# **A12 Chelmsford to A120 widening scheme**

## **DEVELOPMENT CONSENT ORDER CHANGE APPLICATION CONSULTATION**

### **Anglian Water Pumping Station (Bury Lane, Hatfield Peverel) Technical Note**

April 2023

**Plate 1.1 Change to Landtake**

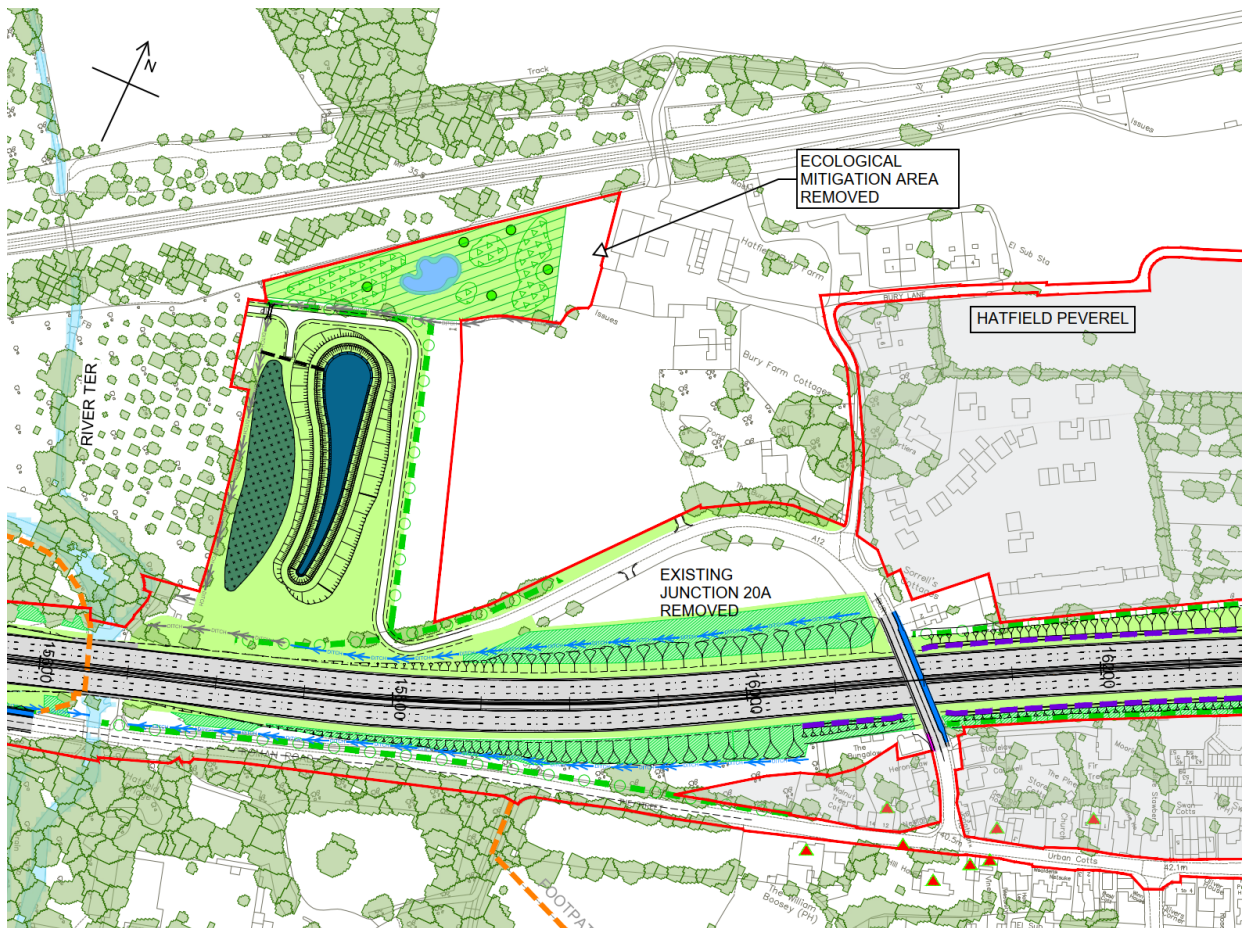
- 1.2.1 The purpose of this document is to explain the proposed change to the extent of an Environmental Mitigation Area as shown on the General Arrangement Drawings (Map Book 2) to accommodate a pumping station at the Bellway Homes Site, Hatfield Bury Farm, Bury Lane, Hatfield Peverel (planning permission 19/01803/FUL). This falls within the Order Limits of the proposed scheme and specifically land plot 5/12c as shown on Sheet 5 of the Land Plans [APP-018]. The Applicant proposes to change the land use at this location from compulsory acquisition for ecological mitigation, to, land not subject to powers of compulsory acquisition or temporary possession. The small area of ecological mitigation that will be lost is a negligible decrease in the overall land

1.3.1 A small area that was identified for acquisition for ecological mitigation purposes in the DCO application, comprises land that has been allocated for a small pumping station to be operated by Anglian Water Limited. After submission of the DCO application, the existing landowner has requested that the land be excluded from order powers to allow the pumping station to come forward as approved. The proposed change has been made following discussions with Bellway Homes and Braintree District Council and will ensure that a planning permission on the neighbouring land (Ref: 19/01803/FUL) would not be affected by the proposed scheme in this regard.

2.1.1 The land take will reduce in this area, as the land associated with the pumping station will be excluded from compulsory purchase powers as set out in the draft Development Consent Order (dDCO). Details of the changes proposed to the land take can be found in Map Book 2 and the Schedule of Changes to the draft DCO, Book of Reference and Statement of Reasons which form part of the consultation materials.
